**Economic Commission for Europe**

**World Forum for Harmonization of Vehicle Regulations****Working Party on Lighting and Light Signalling****Seventy-fifth session**

**Other Regulations - Regulation No. 86 (Installation of lighting and light-signalling devices for agricultural tractors)****Revised proposal for the 01 series of amendments to  
Regulation No. 86 (Installation of lighting and light-signalling  
devices for agricultural vehicles)****Submitted by the Chairs of the Informal Working Group on  
Agricultural Vehicles Lighting Installation\***

Model B  
(See paragraph 4.5. of this Regulation)

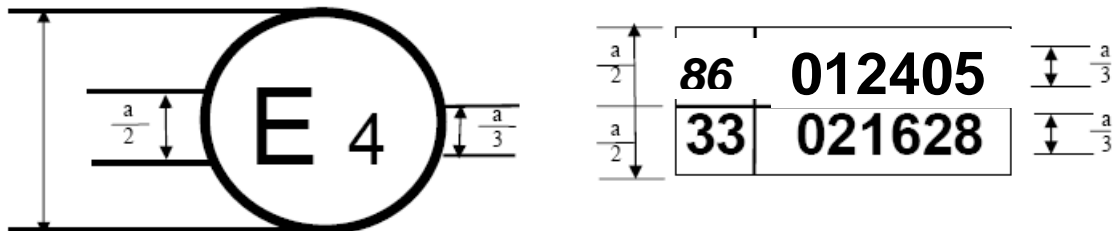
The above approval mark affixed to an agricultural or forestry vehicle shows that the vehicle type concerned has been approved in the Netherlands (E 4) pursuant to Regulations Nos. 86 and 33\*. The approval numbers indicate that, at the dates when the respective approvals were given, Regulation No. 86 was ~~in its original form~~ **as amended by the 01 series of amendments** and Regulation No. 33 already included the 02 series of amendments."

### Direction-indicator lamps - Geometric visibility

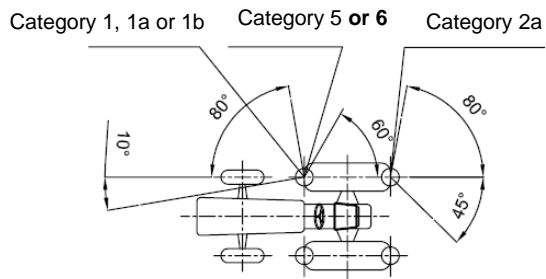
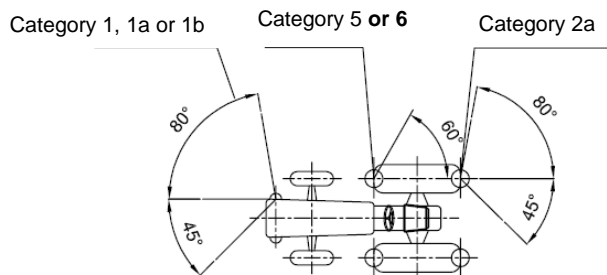
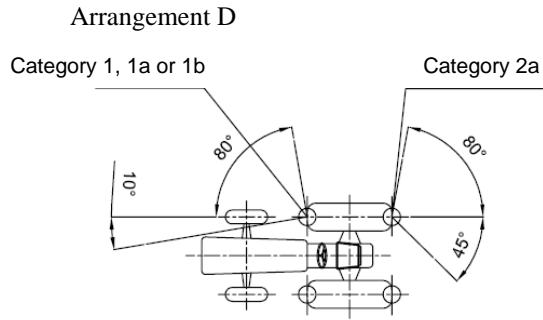
**For all the arrangements the following applies:**

The value 10° given for the inward angle of visibility of the front indicator may be reduced to 3° for vehicles with an overall width not exceeding 1,400 mm.

**For rear direction indicators, the horizontal inward angle may be reduced to 30° if the shape of the bodywork makes it impossible to reach 45°."**

Figure 1.  
Basic standard area

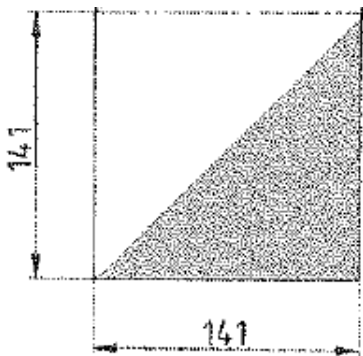
1. Dimensions, arrangement, number and minimum reflecting surface
  - 1.1. Signalling panels and signalling foils shall have the following dimensions:

Figure 2.  
Signalling panel or signalling foil

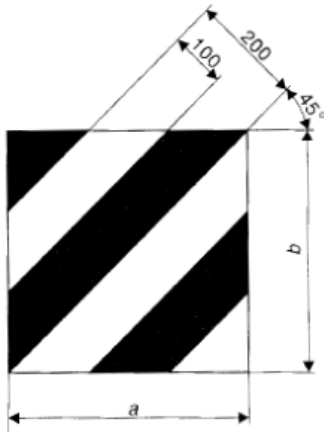
Deviations from the specified formats are permitted, provided that:

- a) the visible surface of each panel or foil shall be at least equal to 4 basic standard areas and
- b) each panel or foil shall comprise at least 3 entire basic standard areas.

If the structure, design or the operational use of the vehicle makes it impossible to comply with such a requirement, each panel or foil may be split into 2 parts as long as each part comprises at least 2 entire basic standard areas.

The panels or foils shall be arranged in a way that their stripes shall run under 45° outwards and downwards.
